Project	IEEE 802.16 Broadband Wireless Access Working Group < http://ieee802.org/16 >	
Title	Action Item from Session #47: Credit token based coexistence protocol text update	
Date Submitted	2007-03-15	
Source(s)	David Grandblaise Motorola Labs Parc Les Algorithmes Commune de Saint Aubin 91193 Gif sur Yvette, France	Voice: +33 (0)1 6935 2582 Fax: +33 (0)1 6935 4801 mailto: david.grandblaise@motorola.com
Re:	Working Group Letter Ballot #24a for IEEE P80216h/D2	
Abstract	During session # 47, several comments (438, 439, 1053, 1054, 1055, 1056) were made to update and clean up text related to the credit token based coexistence protocol. This contribution addresses these comments by presenting some first proposal of text changes.	
Purpose	Action Item from Session #47: Credit token based coexistence protocol text update related to the credit token	
Notice	This document has been prepared to assist IEEE 802.16. It is offered as a basis for discussion and is not binding on the contributing individual(s) or organization(s). The material in this document is subject to change in form and content after further study. The contributor(s) reserve(s) the right to add, amend or withdraw material con

Figure hx: Whole CT-CXP Procedure

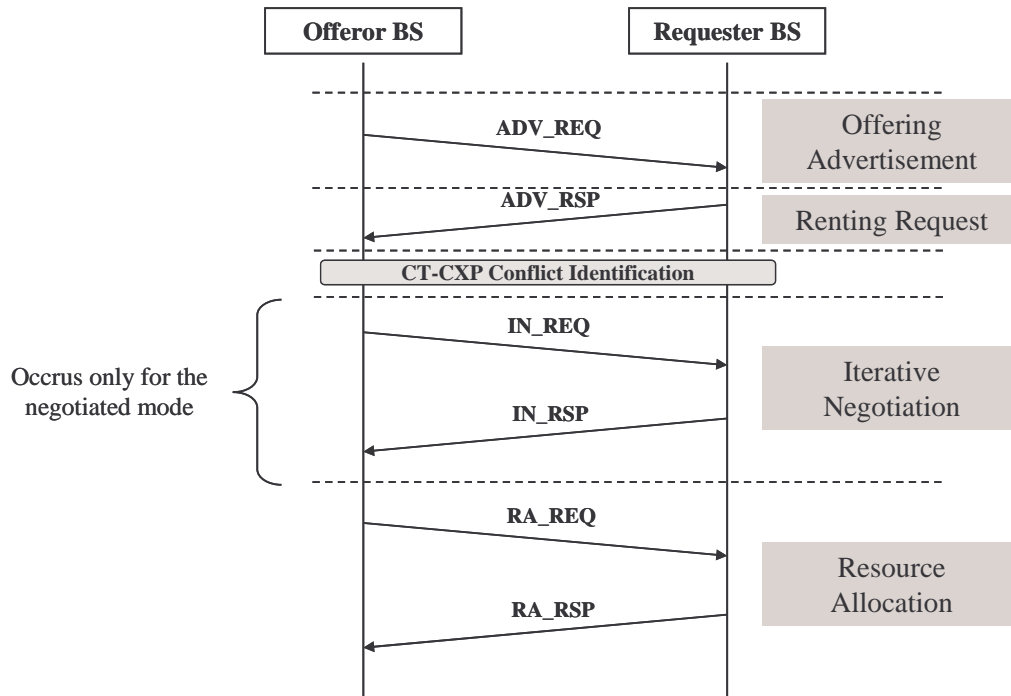
CT-CXP is composed of several consecutive procedures (offering advertisement, renting request, iterative negotiation, and resource allocation) as shown in Figure hx. For the sake of simplicity, this figure is only depicted for one (among multiple) requesters. The corresponding messages exchange between the offeror and the requester for each of the procedures is described in Figure hx. MAC

Figure hy: CT-CXP renting conflicts identification

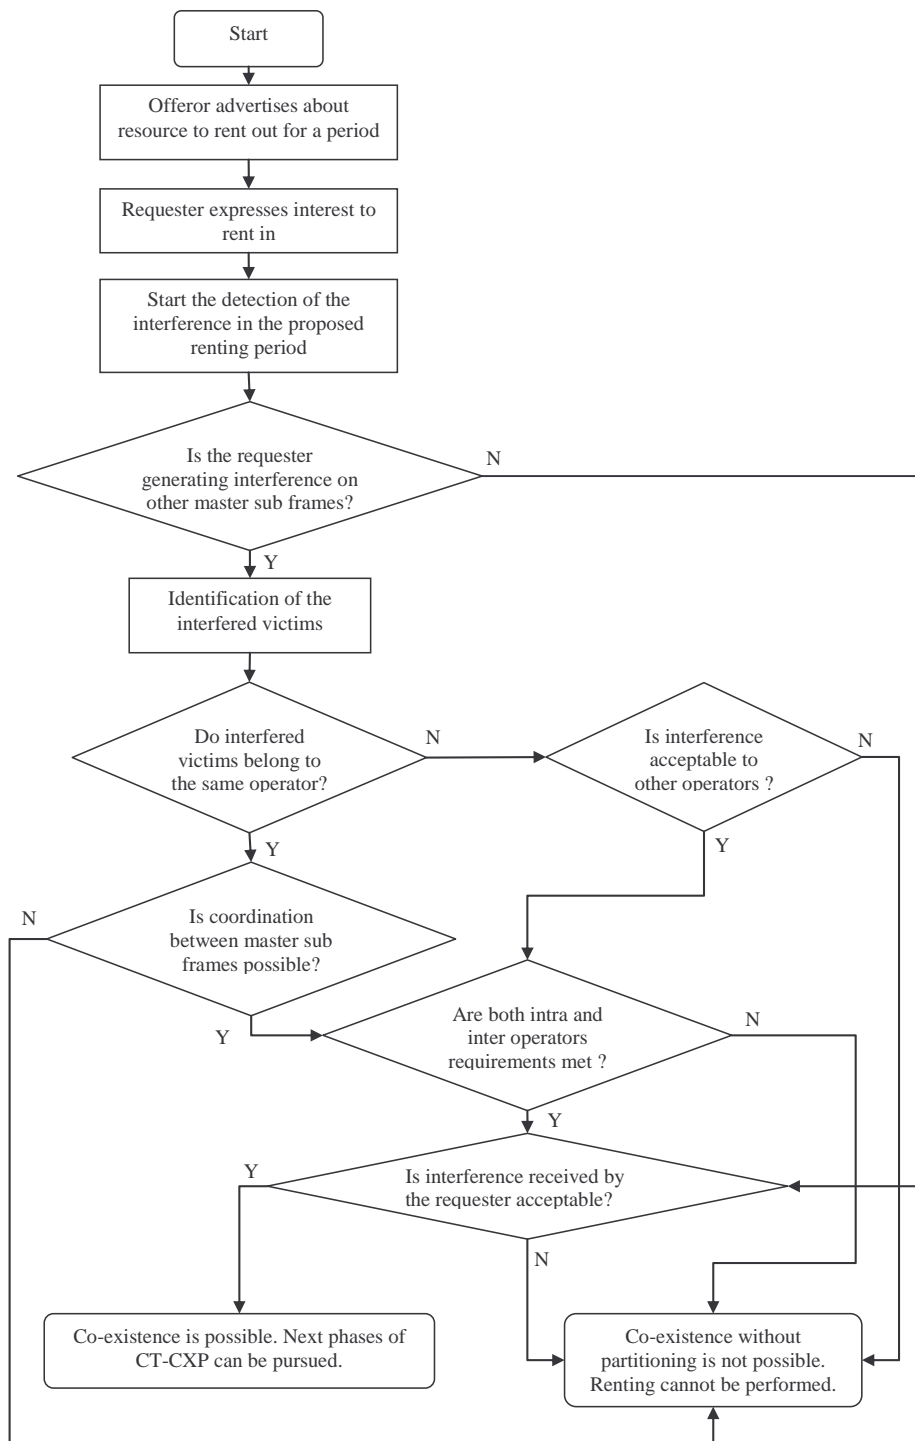
Process of Figure hy aims at identifying the possible coexistence conflicts that could appear if the renting between an offeror and a (or several) requester(s) occur. This process is done prior the offeror actually grants its offered resource to the requester(s). If the coexistence conflicts can be resolved, the iterative negotiation, resource allocation and resource granting acknowledgement (Figure hx) are executed. Otherwise, the whole CT-CXP procedure is stopped and the renting will not occur.

Figure hy takes into account of the coexistence conflicts between the master sub-frames operated by a same operator, or by different operators.

Figure h62—Master-Slave BS communication through the backhaul

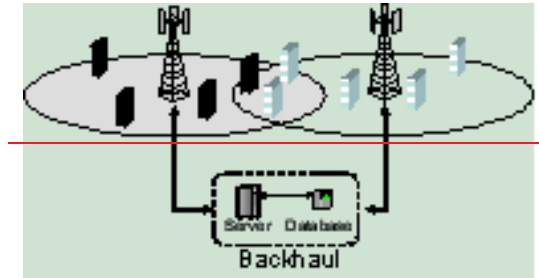
~~4-Master BS-Slave BS communication through the backhaul~~

~~After step 3, the slave BS knows the IP_Proxy_address_M (Section 6.3.2.3.64) associated to the master system. Accordingly, the communications between master and slave systems (BSs) is performed through the backhaul to make the negotiation (Figure h 62) with the coexistence protocol (CXP). The remaining phases of the credit token based negotiation cycle is performed via this backhaul with IP based communications using server(s) and database(s).~~
